Attachment 2

COLA Revision 5 Highlighted Pages for Subsection 2.5.1 Figure RAIs

Turkey Point Units 6 & 7
COL Application
Part 2 — FSAR

Figure 2.5.1-202 Tectonic Map of the Northern Caribbean-North America Plate Boundary (Sheet 1 of 2)

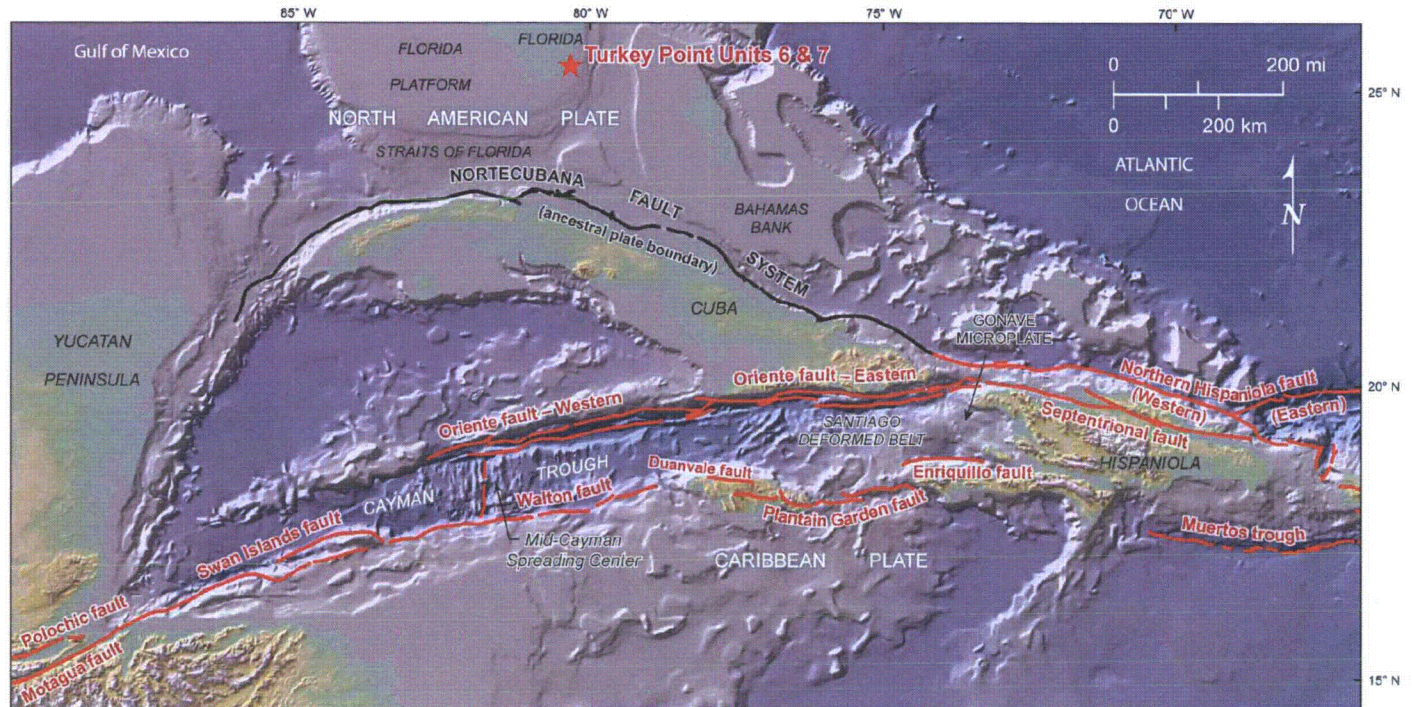
PTN RAI
02.05.01-3

Figure 2.5.1-229 Regional Tectonic Features

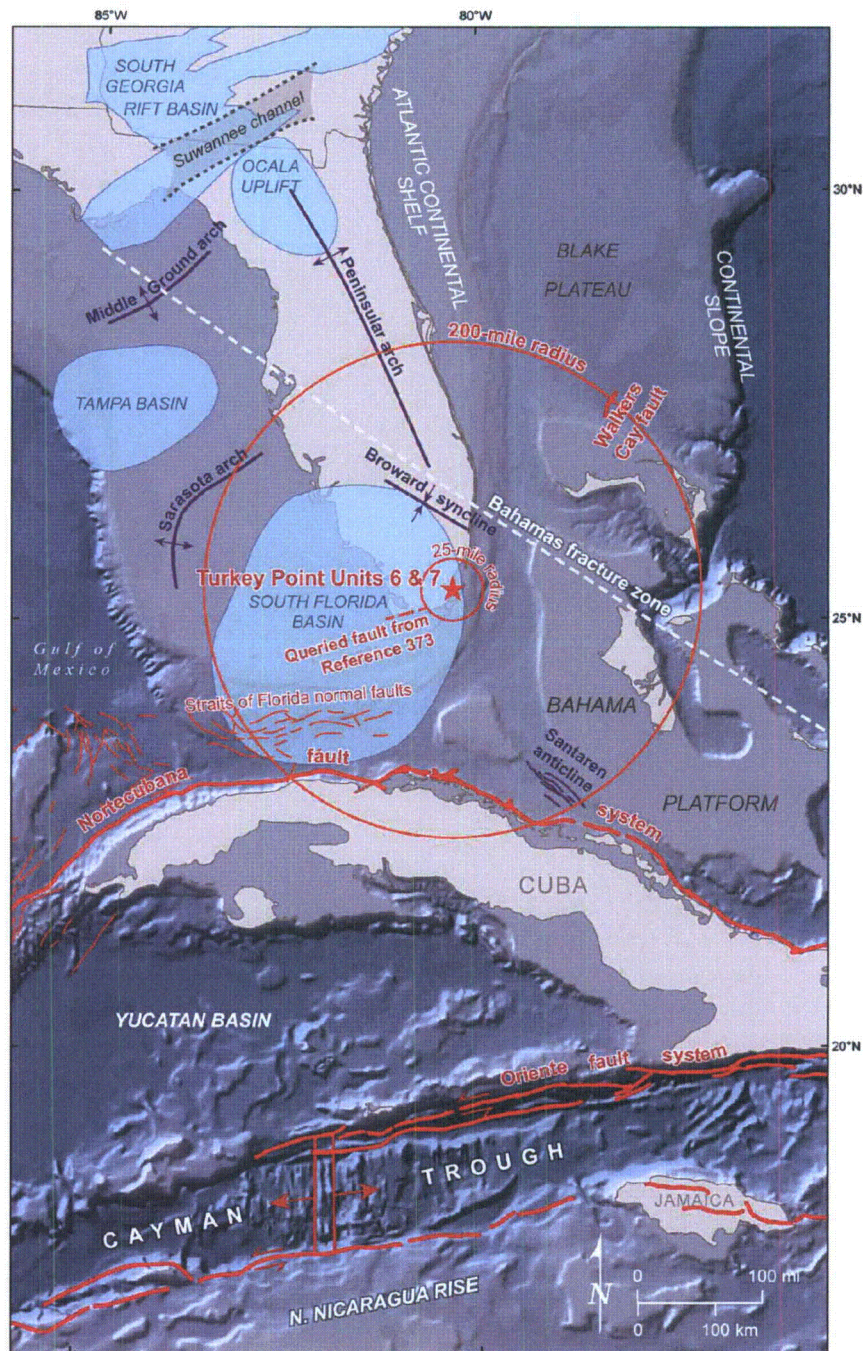
PTN RAI
02.05.01-11

PTN RAI
02.05.01-12

Figure 2.5.1-247 Tectonic Map of Cuba

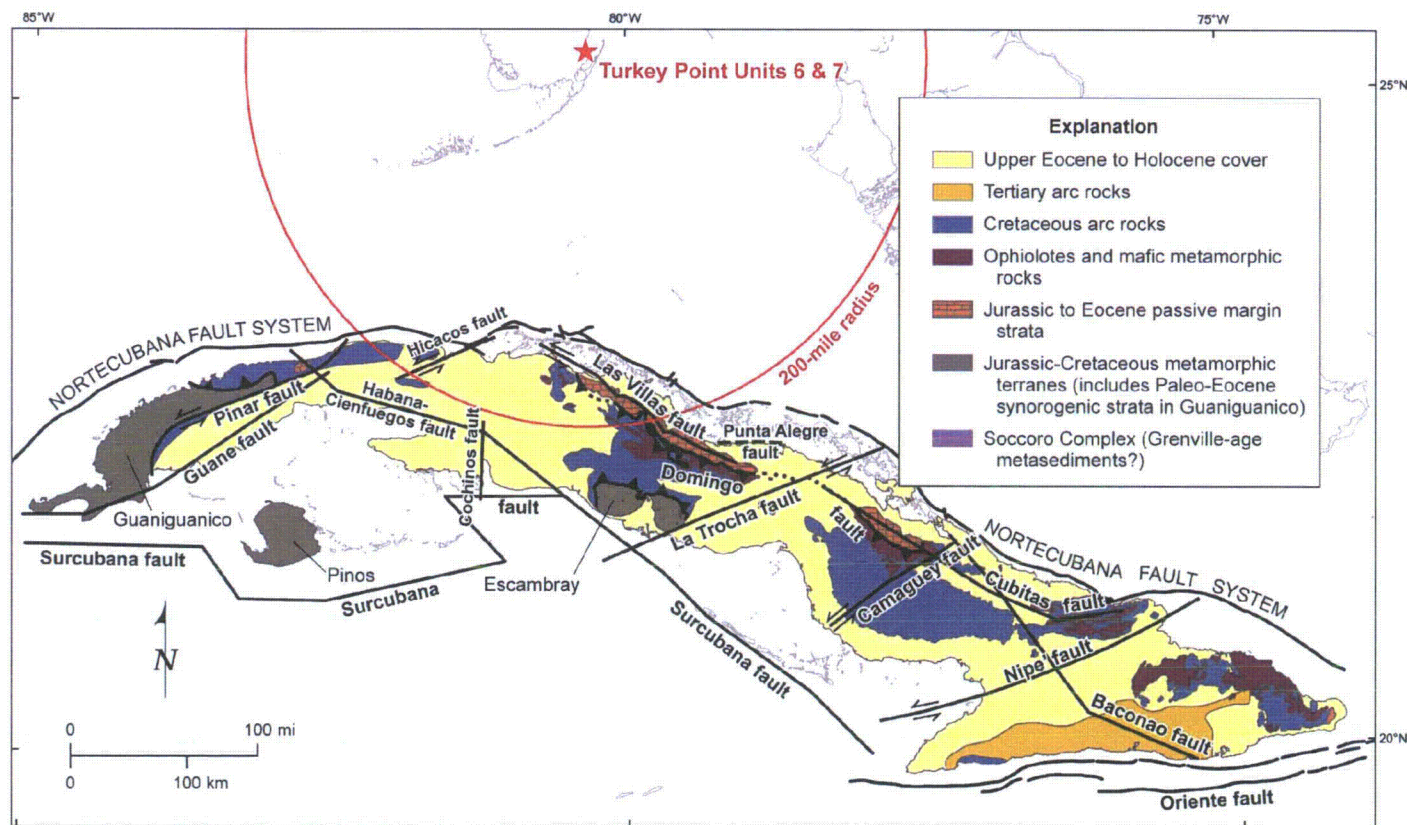
PTN RAI
02.05.01-21
